Re: Safety Recall - Lift-U Wheelchair Lift Linkage

Safety Defect and Noncompliance Report Guide for Vehicles
PART 573 Defect and Noncompliance Report¹

SOLID BAR LINKAGE REPORT

Review and development of a potential modification to solid bar ramp barrier linkage

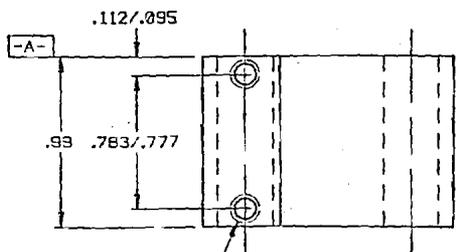
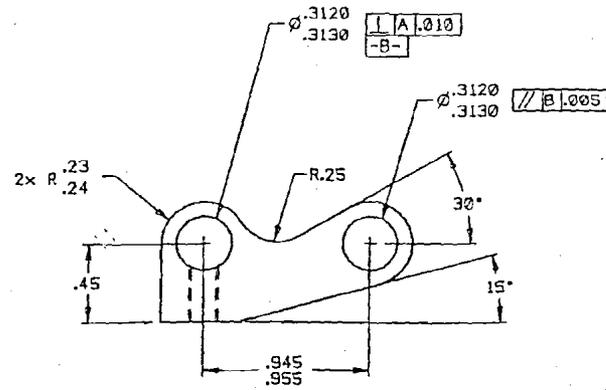
PARTS 184-0042, 184-0041, 123-0288 AND 123-0287 WHICH MAKE UP
THE SOLID BAR LINKAGE AS SHOWN ON ASSEMBLY DRAWING 184-0060

TITLE	SCALE	WEIGHT	DOCUMENT NO.	SHEET NO.	REVISION
CLOSEOUT ASSEMBLY	4:1	0.1406	123-1032	1 OF 1	A

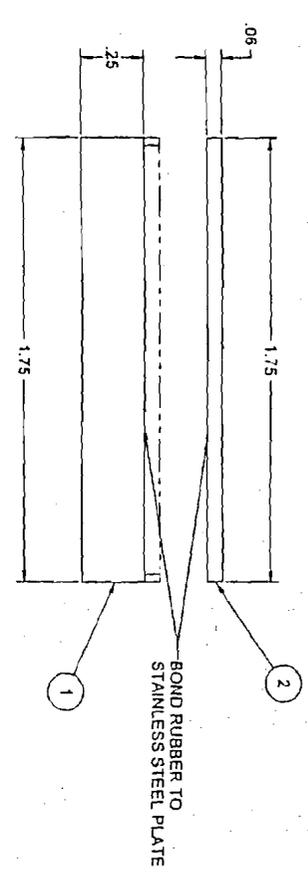
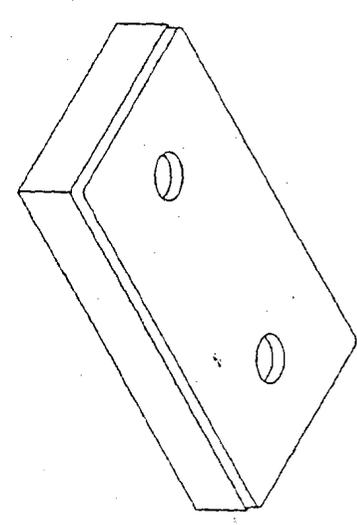
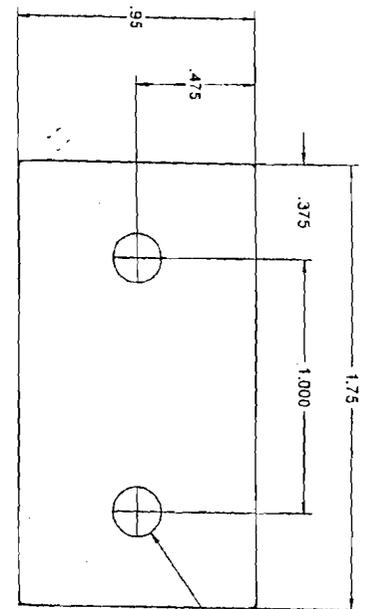
Lift-U will supply free of charge a closeout plate part #123-1029, a closeout assembly part #123-1032, drill template part #524-0197 and rivets along with installation instruction for these parts.

TITLE
LINKAGE CLOSEOUT KIT

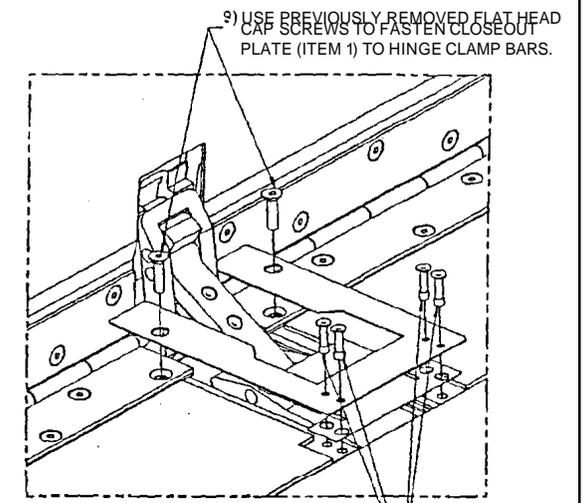
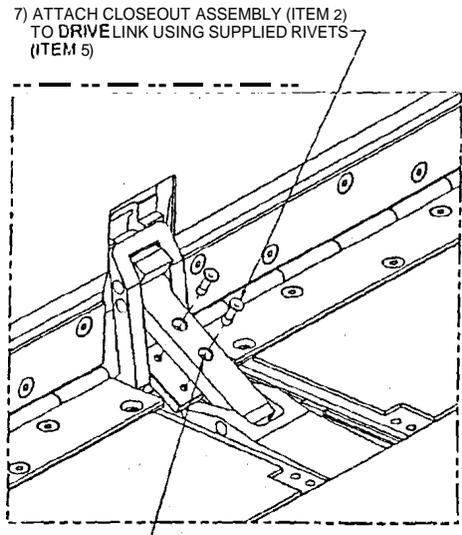
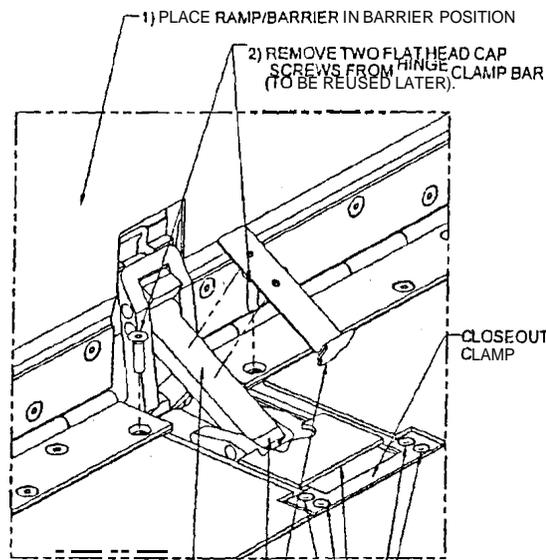
See Lift-U supplied information on the 9-18-06 report – specifically item 6.4. The work to be done is outlined on drawing 123-1033 with parts detailed on drawing 123-1029, 123-1032, and 524-0197.

554 **SEE ITEM 6.4 ON ATTACHED REPORT DATED 9-18-06. THE**
WORK TO BE DONE IS OUTLINED ON DRAWING 123-1033 ALONG
WITH PARTS DETAILED ON DRAWING 123-1029, 123-1032
AND 524-0197.

You are to install the parts as instructed on drawing 123-1033. Return a copy of the "Recall Sheet" we have provided, noting when the installation of parts was completed.

- 5) MARK LOCATION AND DRILL TWO Ø 201 (#7 DRILL) HOLES THROUGH LINK.
- 4) PLACE DRILL TEMPLATE FLANGE (524-0197) AGAINST DRIVE LINK AND CLAMP TOGETHER. HOLES TO BE ON CENTERLINE OF DRIVE LINK.
- 3) REMOVE FOUR RIVETS. CLOSEOUT FLAP AND CLOSEOUT CLAMP. CLOSEOUT CLAMP WILL NOT BE REUSED AND MAY BE DISCARDED.
